SUBJECT: Forwards safety evaluation & description of pressurizer auxiliary spray line design change, per request.

SAFETY EVALUATION AND DESCRIPTION
OF PRESSURIZER AUXILIARY SPRAY
LINE DESIGN CHANGE

DESCRIPTION & ENGINEERING EVALUATION
PROPOSED LIMITED CHANGE PACKAGE (LCP)
NO. 2-6759.OSM, REV. 0

TITLE: Pressurizer Auxiliary Spray Line Modification
San Onofre Nuclear Generating Station, Unit 2

FIGURE 1.1
AUXILIARY SPRAY/PRESSURIZER SPRAY LINE

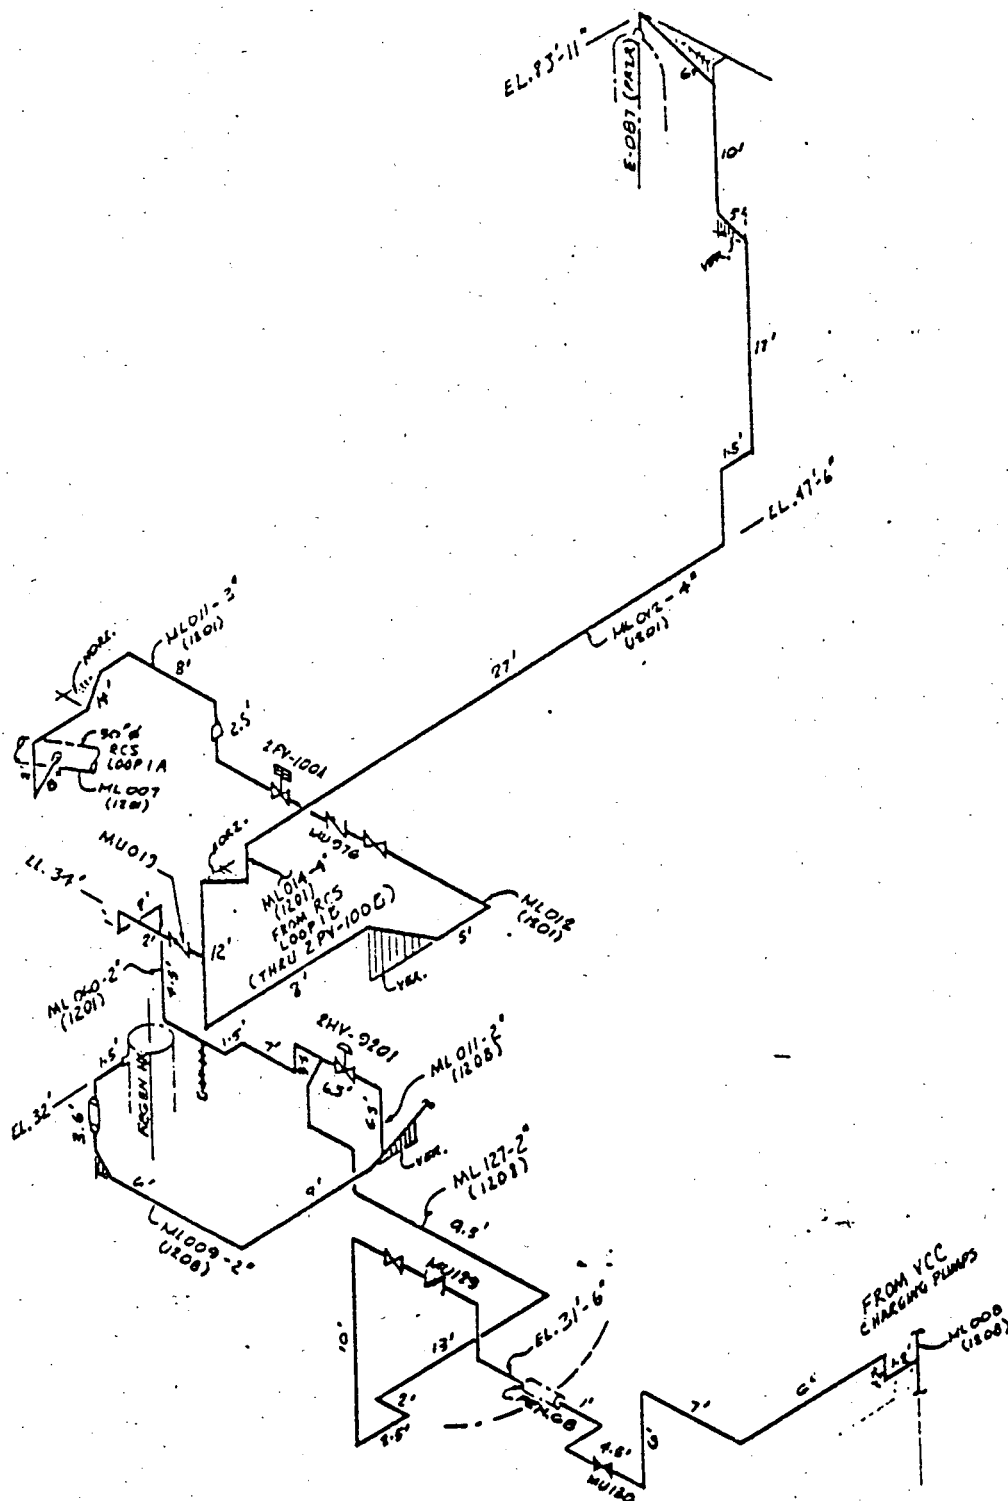
This LCP covers the work necessary to implement modifications to the pressurizer auxiliary spray line, 1201-060-2", in accordance with the SCE evaluation of the potential for leakage induced thermal stresses in response to NRC Bulletin 88-08. The modifications include the relocation of check valve, 1208MU019, which is currently located in the horizontal run of the 2 inch auxiliary spray line, five inches upstream of the tee connection to the vertical run of the 4 inch main pressurizer spray line, 1201-012-4", Figures 1.1 and 1.2 show the existing line configuration and the relocation zone of check valve, MU019 respectively. In addition, a minor reroute of the auxiliary pressurizer spray line is necessary to accommodate the existing pipe supports and the revisions to the pipe supports as part of the snubber reduction program being done in DCP 2-6683.2BP. This routing change extends the piping in the north direction by 1'-8" as shown in Figure 1.3.

The purpose for making this modification is to prevent high thermal cyclic stresses at the check valve due to cold water leakage through the single isolation valve, 1208MU130. As described in NRC Bulletin 88-08, this type of leakage, i.e., cold water leaking into a hot pipe through check valves, was found to cause high temperature transients just downstream of the check valves which resulted in pipe cracking due to high cyclic stresses. The changes proposed will relocate the check valve to a cold section of the line so that the high cyclic thermal stresses cannot occur. The change does not affect the current design basis, P&ID's, or operating procedures for the pressurizer spray system, or any other system.

FIGURE 1.2
RELOCATION OF CHECK VALVE, MU019

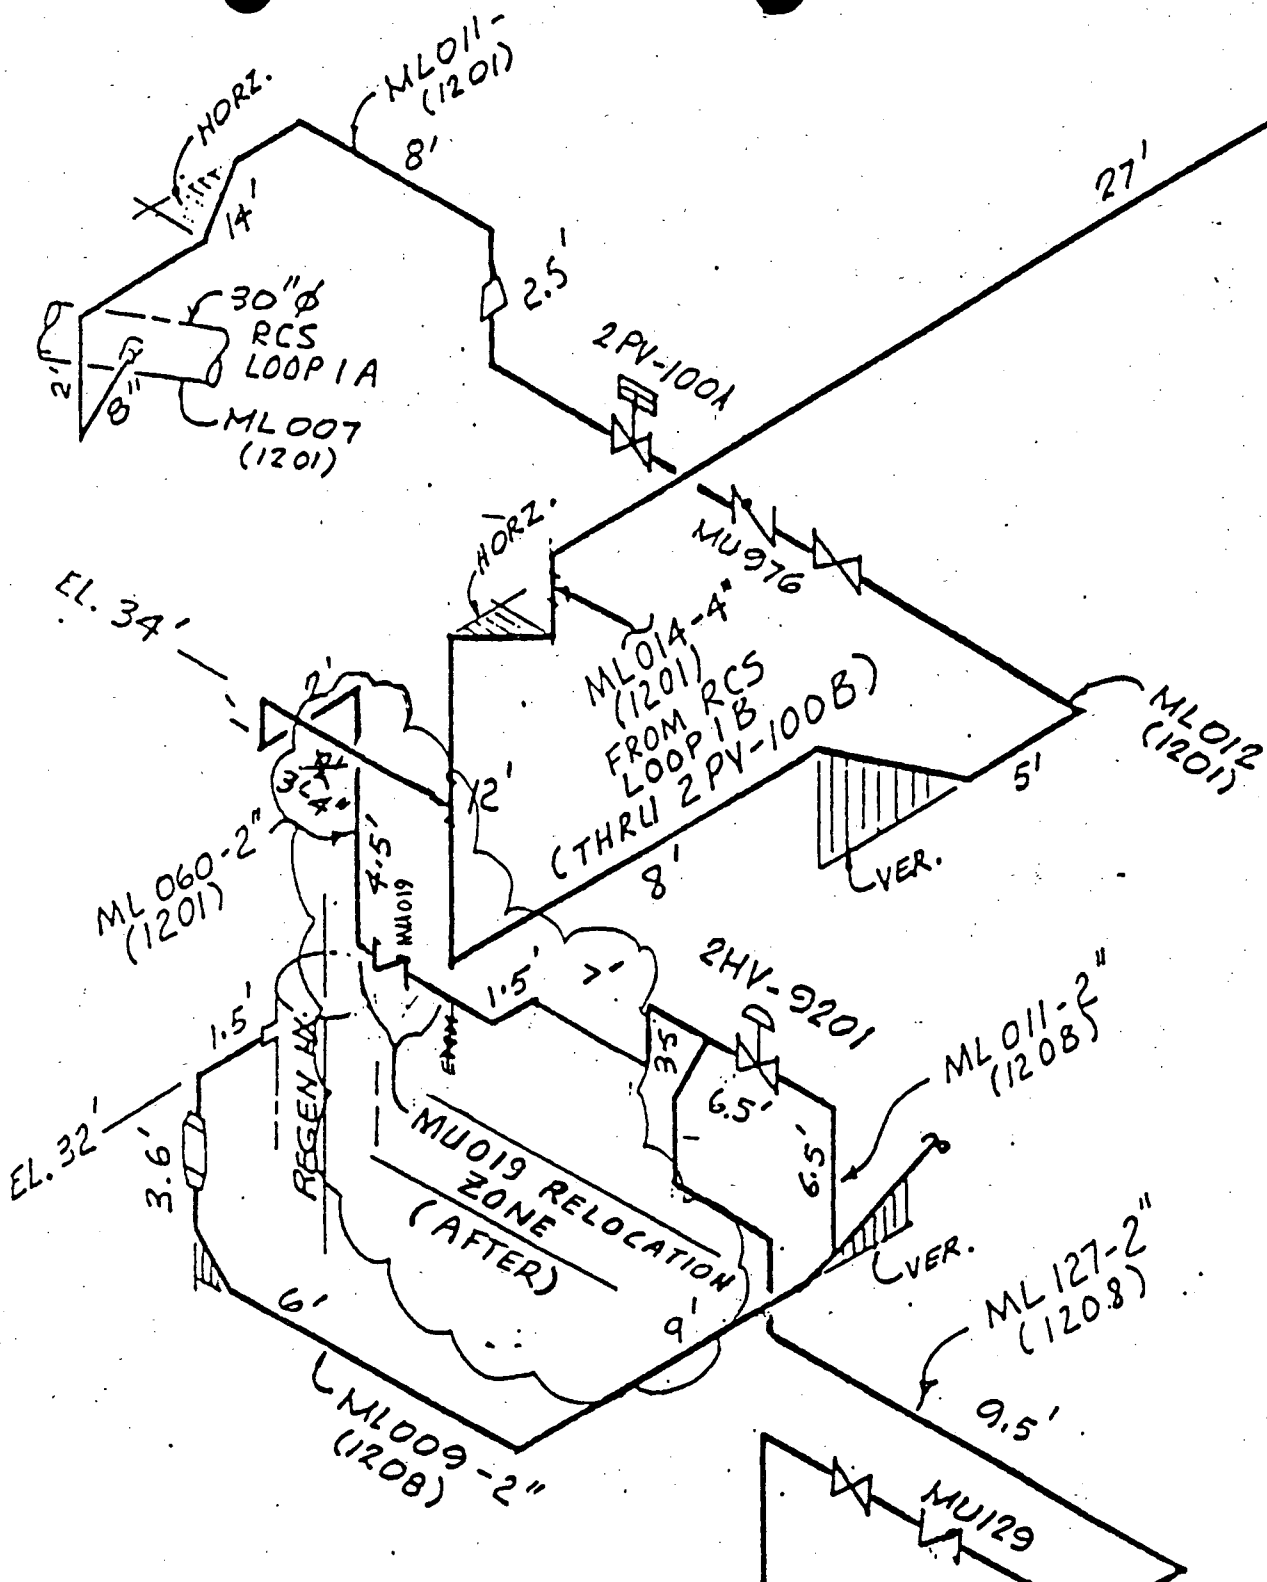
4. The modification does extend the RCS unisolable boundary. By relocating check valve, MU019, to the new upstream location, approximately 10 feet of 2 inch piping are added to the RCS unisolable boundary. This extension of high energy piping does not create any new HELBA considerations not already evaluated. A change to the UFSAR Appendix 3.6A is required to show the high energy boundary location change as shown in Figure 3.6.A and the pipe break stress analysis table reflecting the results of the piping stress reanalysis being done under DCP 2-6683.2BP (Reference 3) for the Snubber Reduction Program.

The support modifications on line 1201-060-2" to be implemented as part of DCP 2-6683.2BP include, changing one snubber to a rigid strut at supports RC-060-H051 and H052 in the vicinity of relocated check valve, MU019.
